City of Santa Barbara California

STAFF HEARING OFFICER STAFF REPORT

REPORT DATE: November 1, 2006
AGENDA DATE: November 8, 2006
PROJECT ADDRESS: 822 E. Canon Perdido (MST2005-00506)
TO: Staff Hearing Officer
FROM: Planning Division, (805) 564-5470
 Jan Hubbell, AICP, Senior Planner
 Chelsey Swanson, Assistant Planner

SITE PLAN & COMPOSITE UTILITY PLAN

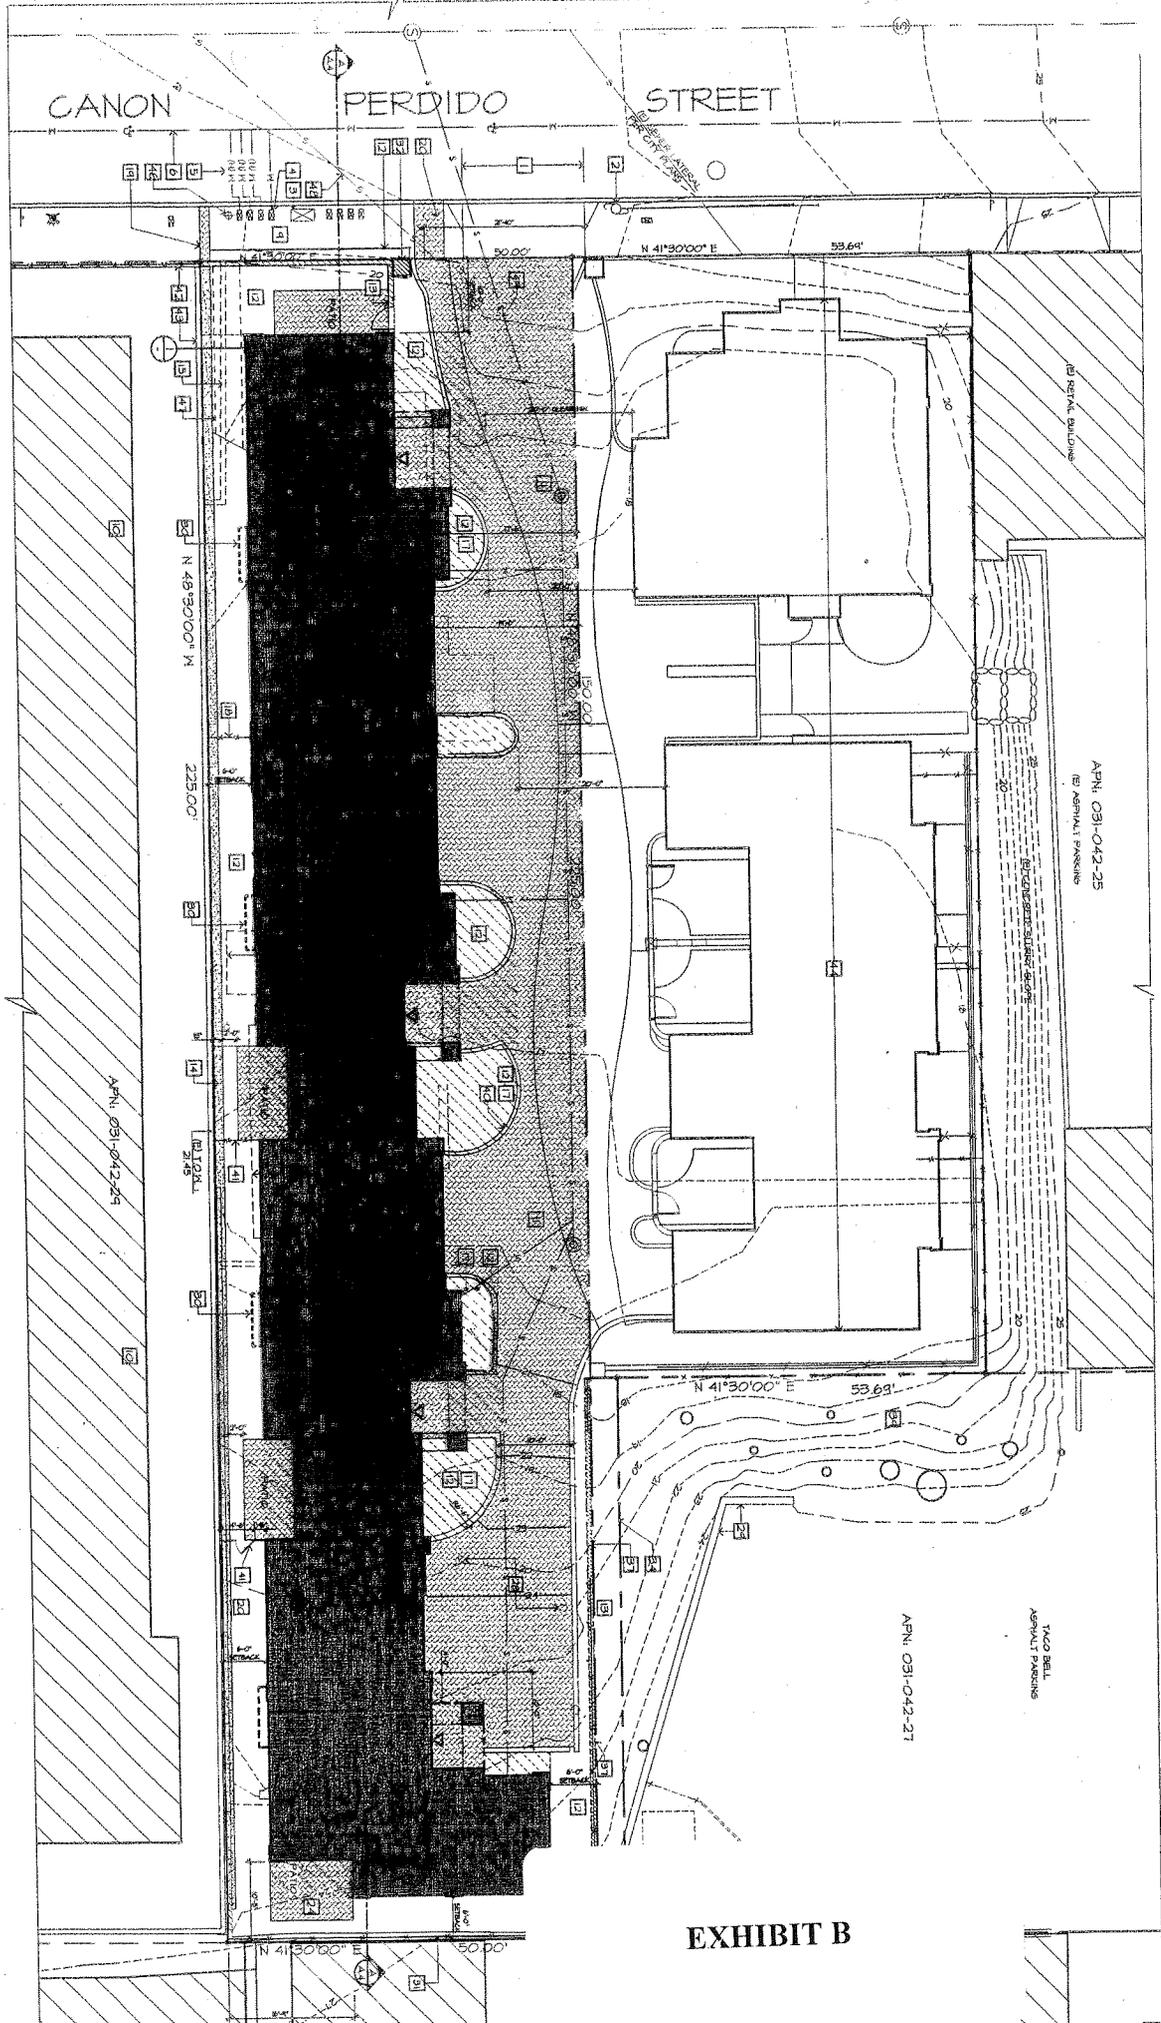
The Commissioners requested the possibility of a vegetated swale instead of the proposed hard-surface swale along the narrow west side yard be studied further. The applicant explains in the attached letter (Exhibit C) that the project civil engineer has determined a vegetated swale is not feasible for this site unless slope of the site was increased and additional retaining walls were proposed; and therefore, the applicant is still proposing a concrete swale. A concern was also raised with regard to the height of the building and how it would relate to the existing residential apartment building to the south, potentially creating a "12-foot canyon" effect and impacting the neighbors' second-story outdoor living areas. The adjacent building is approximately 18' tall, and the proposed building would be approximately 7' taller as seen from Canon Perdido Street. The Architectural Board of Review (ABR) found the building height in relation to the adjacent apartment building to be appropriate, and therefore, the applicant has not changed the height of the building. At the time of conceptual review, the project included a modification request to allow a trash enclosure to encroach into the rear yard behind Unit D. Although the Planning Commission was supportive of the modification request, the project has been redesigned so that no modification is required. Finally, the Commissioners liked the art deco styles of both 824 and 822 E. Canon Perdido and felt that they were compatible developments.

The Planning Commissioners at the joint PC/SO hearing (May 11, 2006) requested that the possibility of a vegetated swale instead of a hard-surface swale along the narrow easterly side yard be studied further. There are many reasons why a vegetated swale on this site is not feasible. As our civil engineer has confirmed, a vegetated swale requires a 3% to 5% slope. We only have a 1.5% slope from the rear to the front of the property. To increase the slope percentage sufficiently would require greatly increasing the amount of fill coming to the site and would necessitate **additional** retaining walls, 4' and higher around the rear and sides of the lot. The new retaining wall (already shown on our plans) along the westerly property line would also double in height, raising it to over 6'. Furthermore, a vegetated swale relies (in part) on the soil to absorb portions of the run-off. In an extreme storm event, if the ground becomes saturated and water cannot escape from the site quickly enough, then the water has no place to go except into the units or into our neighbors yard, thereby very likely flooding their units.

3. With regard to the drainage, asked to continue pursuing vegetative swales between 822 Canon Perdido and neighboring buildings. Supports noise study but would hope that a modification could be granted to keep the front deck and facilitate the cow overlook. Supports the requested variances and modifications as well as the art

4. Commends the two project designers for working together and supports modifications. Likes the solar features. With regard to problematical drainage, suggests another look at hard swale versus soft swale. Feels it will be a challenge for two homeowners associations to work together to maintain one driveway.

2. **Dedication(s).** Easements as shown on the approved Tentative Subdivision Map described as follows, subject to approval by the Public Works Department and/or the Building and Safety Division:

- a. A 5-foot wide easement for storm drainage purposes as shown on the approved Tentative Subdivision Map.
 - b. A reciprocal access easement variable in width for vehicles on APN 031-042-006 and APN 031-042-007.
